UNITED STATES
NUCLEAR REGULATORY COMMISSION
WASHINGTON, D.C. 20555-0001

FACILITY: Point Beach Nuclear Plant, Units 1 and 2

SUBJECT: SUMMARY OF MARCH 17, 2010, MEETING WITH NEXTERA ENERGY POINT BEACH, LLC, REGARDING RESPONSE TO GENERIC LETTER 2004-02 (TAC NOS. MC4705 AND MC4706)

DRAFT RESPONSES TO GL 2004-02 RAIs
POINT BEACH NUCLEAR PLANT

Please refer the annotated drawing of Unit 1 on the next page that shows the DIs being removed.

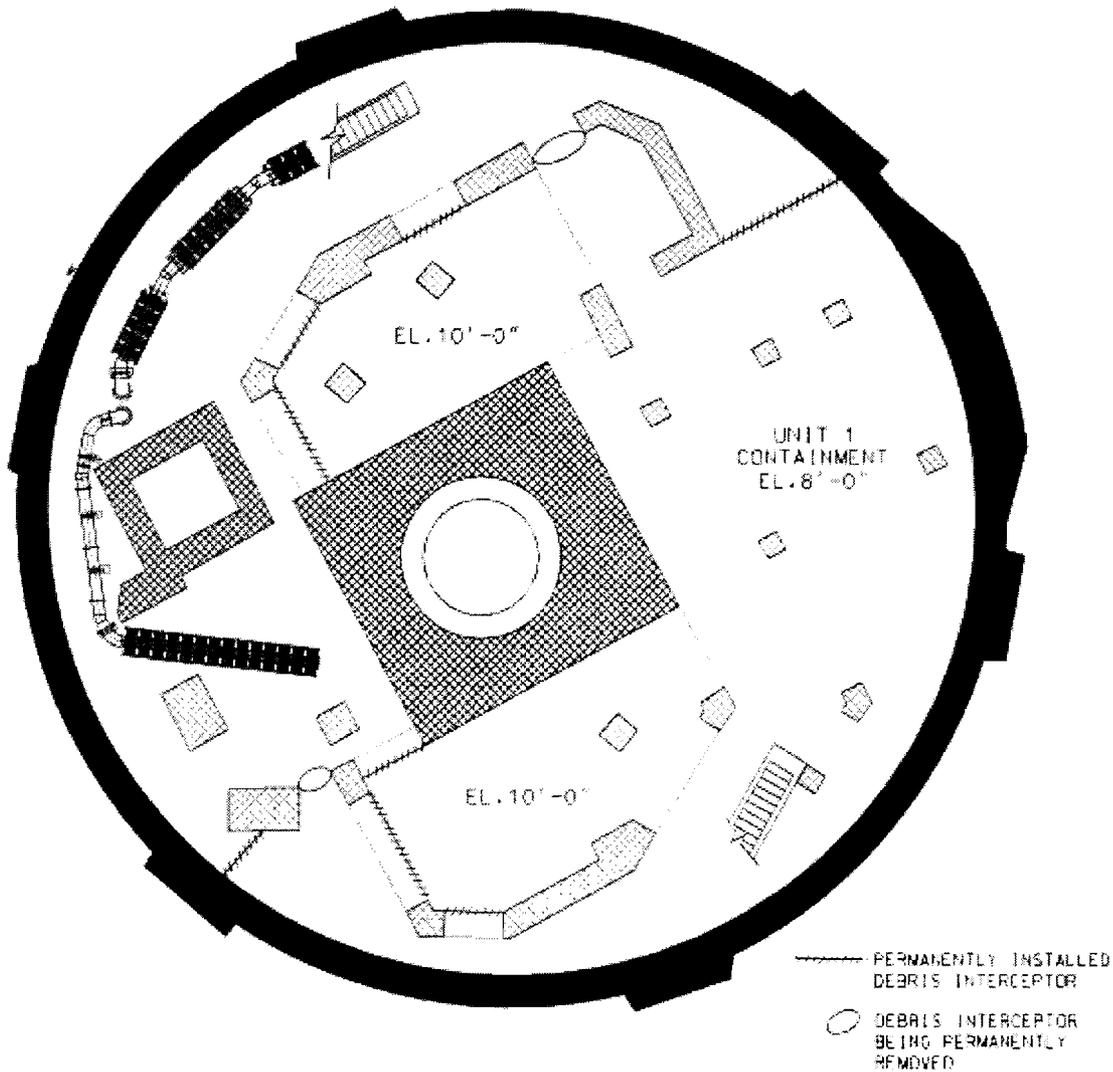
Question 13

Please provide the basis for concluding that debris blockage will not occur at the debris interceptors (including the submerged perforated surface area and 4-inch slots) at Unit 1 to an extent that would result in starvation of flow to the sump strainers.

The question of potential DI blockage is being eliminated entirely by the removal of two of the DIs. The two DIs being removed are an impediment to efficient outage execution because they block access to significant parts of the containment lower elevation and must be physically removed and re-installed each outage. The DIs are not credited for holding back debris. In the future, all of the DIs, as well as other modifications that no longer serve any purpose that can be credited in the sump screen performance analyses and testing (e.g., the re-routed cavity drain line away from the strainers) may be removed.
